**Tea & Tiaras  
Princess Party Parlor**  
3500 S. Meridian Ave Puyallup WA 98373

City of Puyallup  
Development & Permitting Services  
**ISSUED PERMIT**

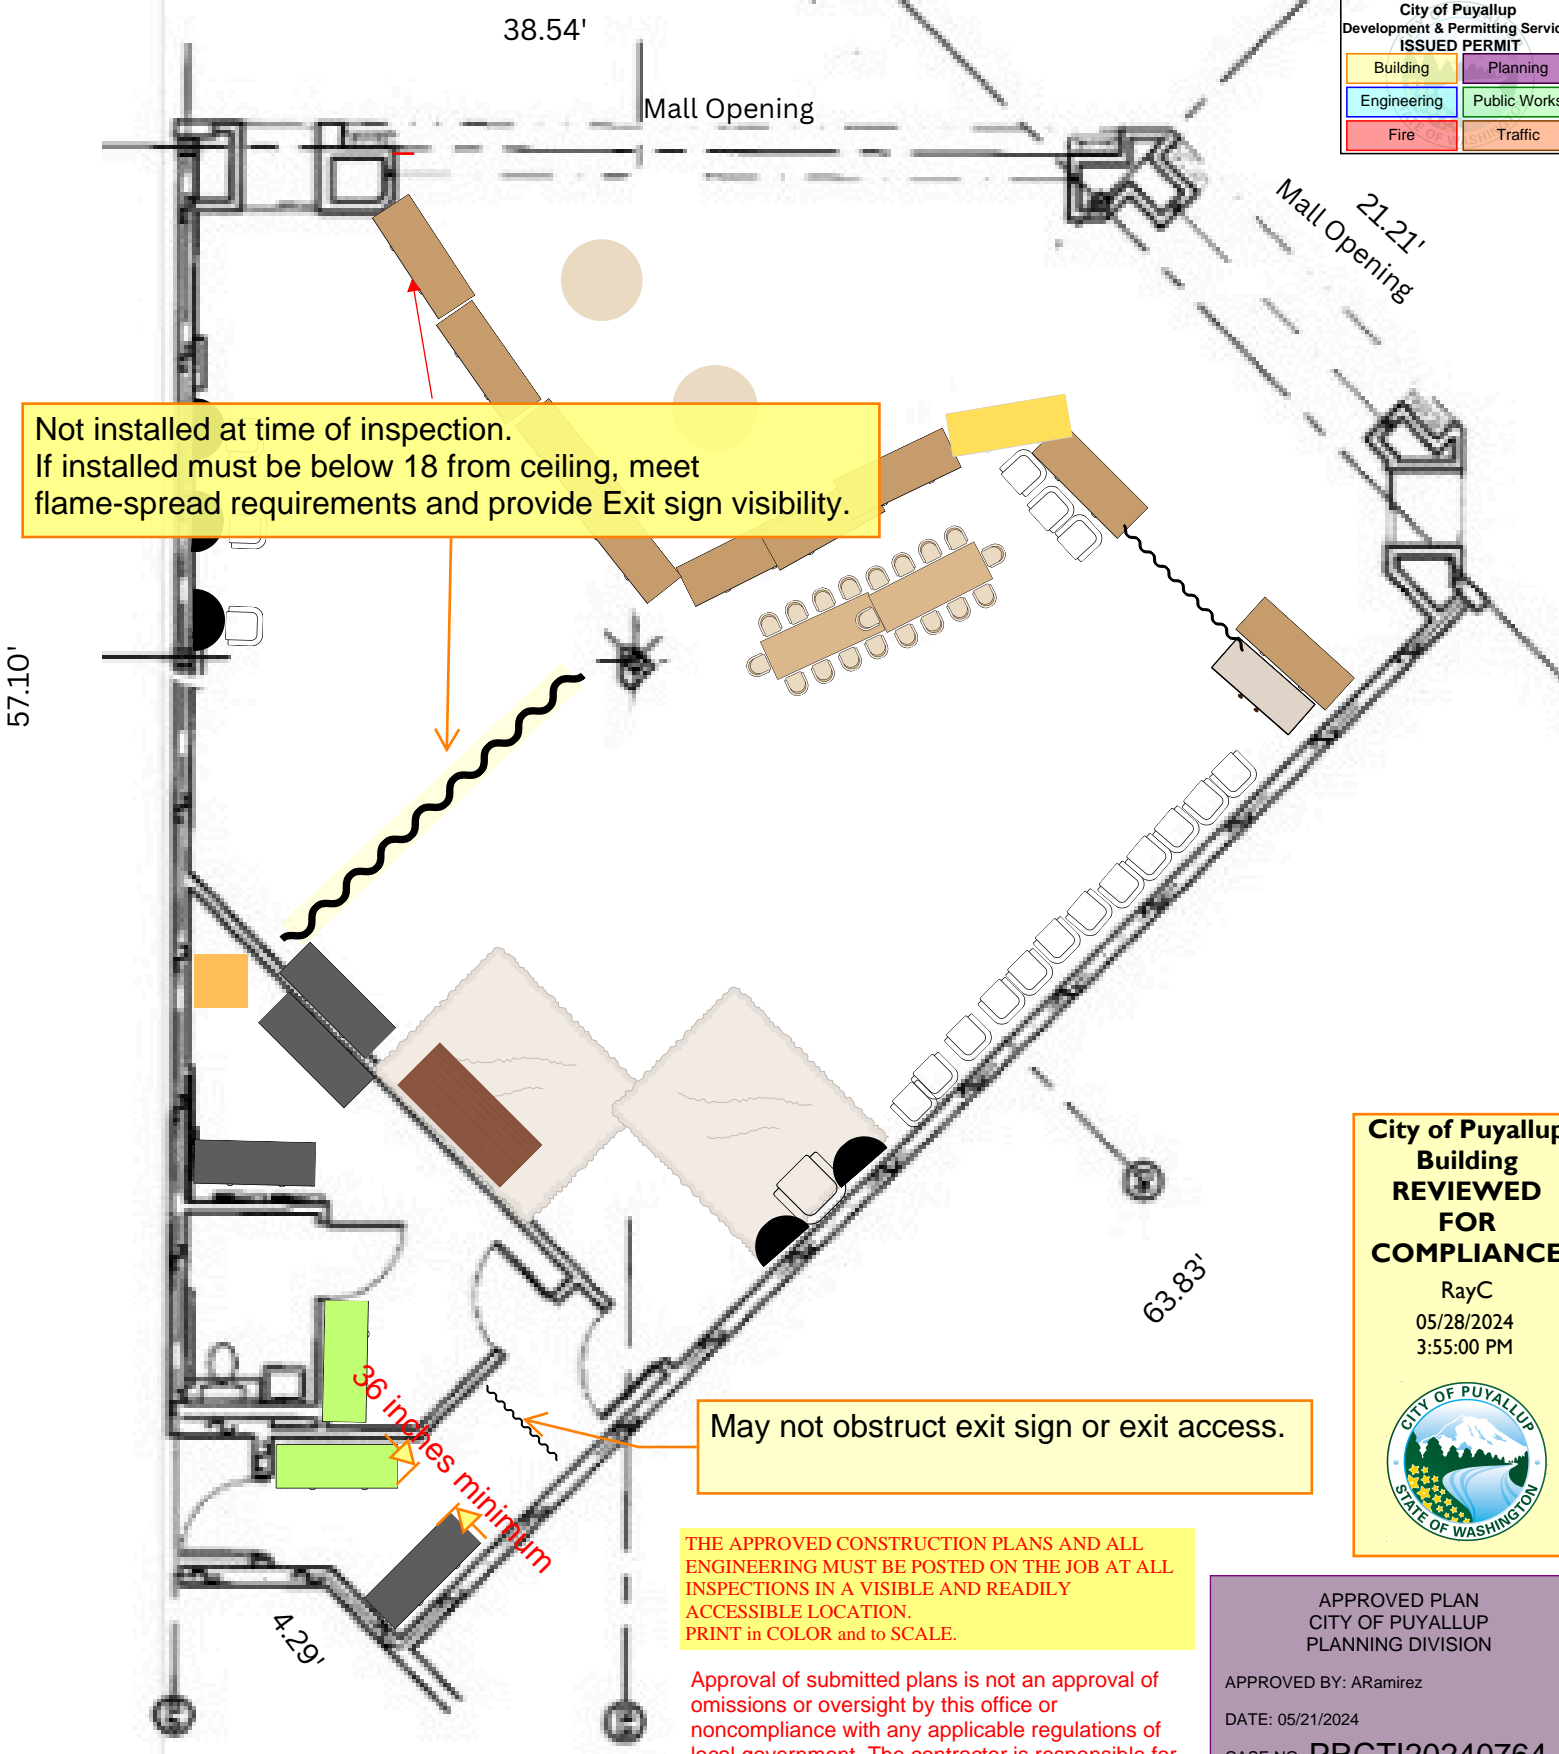
Not installed at time of inspection.  
If installed must be below 18 from ceiling, meet flame-spread requirements and provide Exit sign visibility.

May not obstruct exit sign or exit access.
